# Supporting Documentation

## Prestbury St Peter – Monastic garden

<b>Ref:</b>	2019-029334	<b>Church:</b>	Prestbury: St Peter
<b>Diocese:</b>	Chester	<b>Archdeaconry:</b>	Macclesfield
<b>Created By:</b>	Mr Steve Hill (14/01/2019)	<b>Contact Tel.:</b>	01625 613681
<b>Status:</b>	Awaiting DAC recommendation

### Proposed Monastic Garden – Revised and consolidated Statement of Need

SPP-1122a

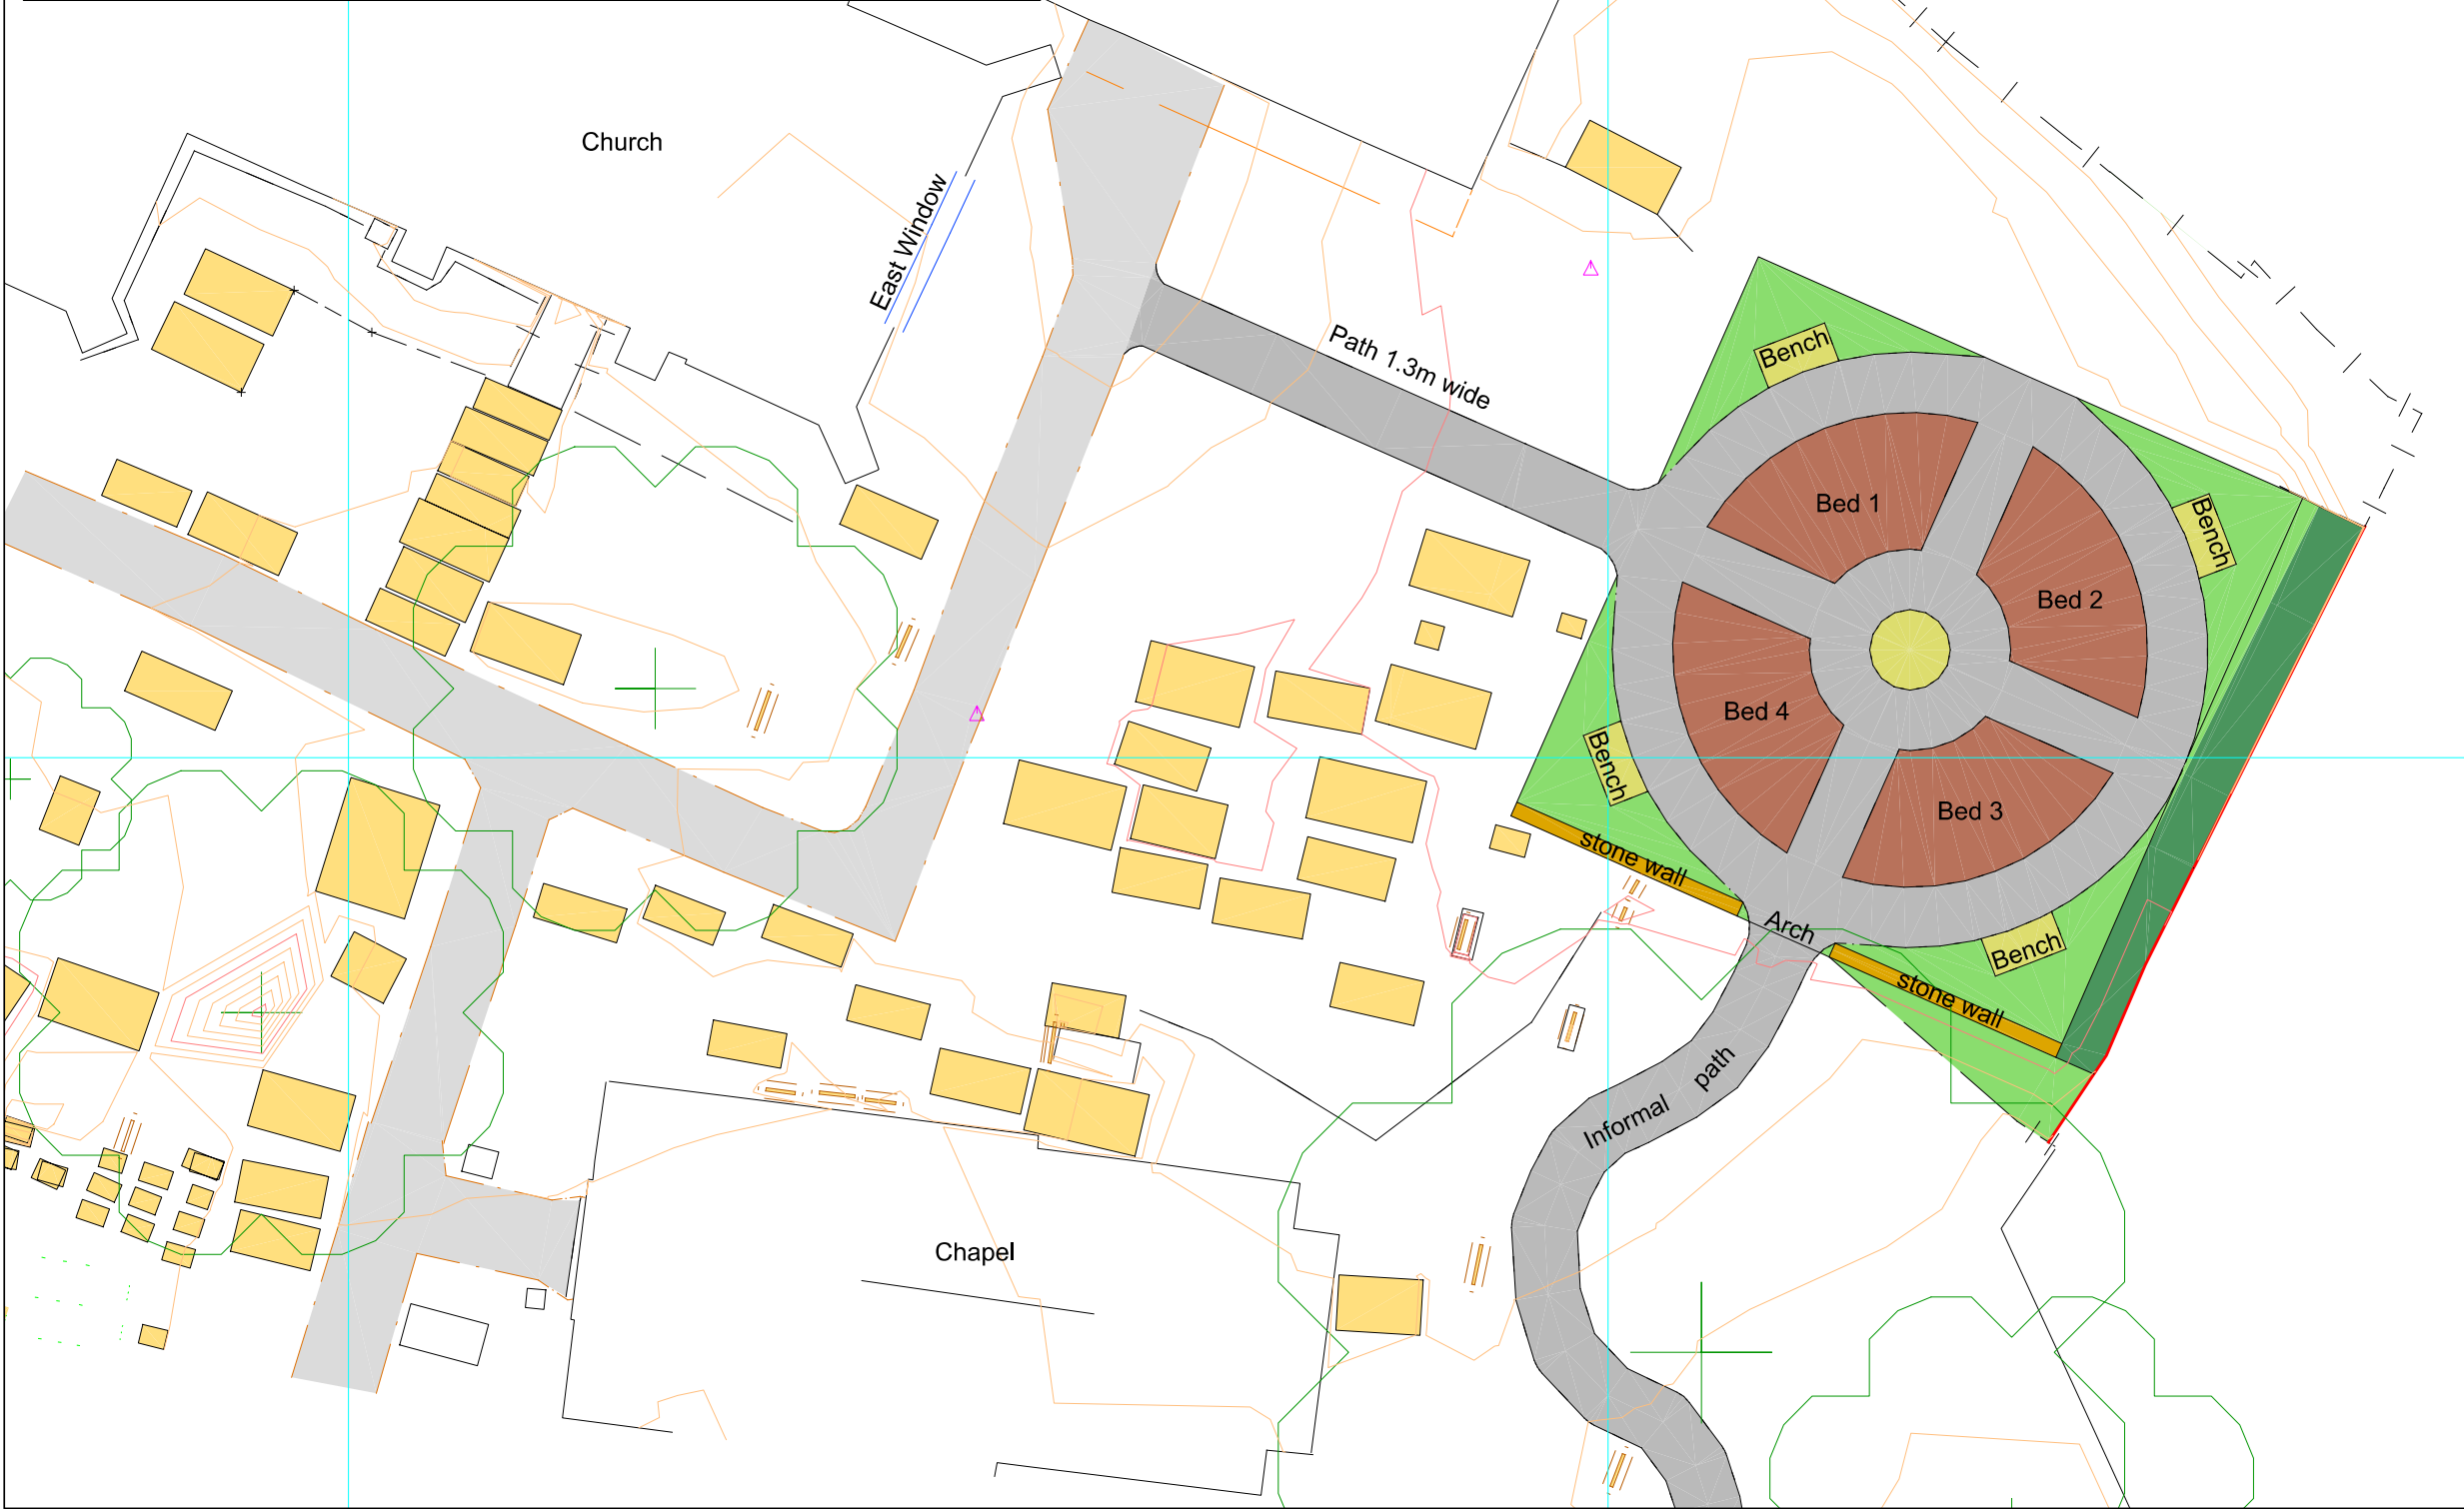
The PCC considered the DAC's comments made at its meeting on 27 July 2021 (See Appendix hereto) on the preliminary Statement of Need outlining the design of the proposed Monastic Garden.

- a. It would maintain its recommendation if the proposed cloister-like structure was removed from the scheme. If the parish removed this proposed structure from the scheme the DAC office could therefore progress the faculty application by processing the Notification of Advice (and therefore allow the public notice period to commence) under delegated powers. In the meantime the parish could work up the details for this structure as a separate faculty application.*

- b. If the parish wished to go forward with the proposed cloister type structure further details would be required which the DAC would need to consider. These details should illustrate the construction details and appearance of the wall. The structure should be designed to look attractive and have a good level of craftsmanship as its scale means it will change the character of the churchyard.*

- c. In addition to faculty permission the parish would also need to obtain planning permission for the structure*

- a. The Sub-Committee encouraged the parish in its development of the proposals.
- b. It considered that the monastic garden would enhance the space, but its appearance needs to be fully thought out beyond the boundaries of the square outline, and the parish should consider the wider landscaping of the surrounding churchyard.
- c. In the plan drawing it appears that the square outline is very tightly drawn around the proposed garden and doesn't seem to provide much room for features such as trees and benches.
- d. The Sub-Committee observed that the monastic garden may make that area of the churchyard a more attractive area for burials
- e. It questioned whether there is plenty of capacity for burials generally in the churchyard
- f. It noted that children would find a rock very tempting to climb on

The final point is currently under consideration. However, given the significant potential delays to the project that a planning application will involve, the DAC's advice – for which the PCC is grateful - to restrict its application for faculty approval to the design and landscaping of the proposed garden itself, as Phase 1 of the project (as shown on the accompanying plan – i.e., without the “cloister” and retaining wall), is accepted. A further application for these features will be made when details are to hand. The implementation of Phase 1 of the project can be carried out without the need for their contemporaneous development, which will thus form Phase 2 of the project.

- a ground design based broadly on a Saxon Cross: a circle intersected by 4 pathways to a central roundel. The circle would be contained within a square, thus providing 4 further peripheral areas within which benches could be placed.

- orientation would be defined by the shaft of the cross (a pathway) leading from the existing pathway to the new parish rooms annex aligned with the centre of the East Window of the church.

- the north-west and north-east corners of the square would be defined with low-cut yew hedge plants extending some 2 metres laterally in each direction.

- the existing fence along the eastern boundary would be removed and replaced with a tensioned post and plain wire fence, set back approximately 0.75m closer to the boundary of the churchyard, against which espalier or cordon fruit trees would be planted and trained.

- the south and west boundaries of the square would be defined respectively with a low drystone wall with an archway linking the garden to the existing informal pathway to the south, and further low-cut yew hedge plants.

- a planting plan for the 4 beds will be prepared which follows traditional monastic themes of culinary, medicinal, and sensory (but probably not poisonous) species.

- the paths will be defined by steel plate upstands to contain the soil within the beds and surfaced in a gravel-filled heavy-duty plastic or nylon mesh laid on a compacted sub-base and geotextile membrane.

- the central roundel and the bench areas will be surfaced with random flag stones, flush grouted.
- the southern boundary wall - c 0.7m high - will be of random stone fragments sourced from within the churchyard, bedded in mortar.

- the benches will be in traditional timber and will have a common design.
- Some minor regrading within the site will be needed to achieve a uniformly level surface at c.105.9. AOD.

In terms of the wider landscape context for the proposal, this area is part of a relatively small, discrete and enclosed area of the churchyard, lying as it does between the East end of the church, with its impressive stain-glass east window, the main community entrance to the St Peter's Rooms annexe and the Norman Chapel. It is thus separate from and well away from the much larger, more heavily traffic'ed and more informal and loosely managed part of the churchyard.

Re comment (c), the available space for a discrete formal garden area is restricted. It is considered important for the area to be clearly defined as a separate area of the churchyard intended for a specific purpose or purposes. The number of benches should be restricted to the number shown, given the importance of the garden as an area of quiet contemplation.

Re (f) The proposal for a rock feature has been dropped.
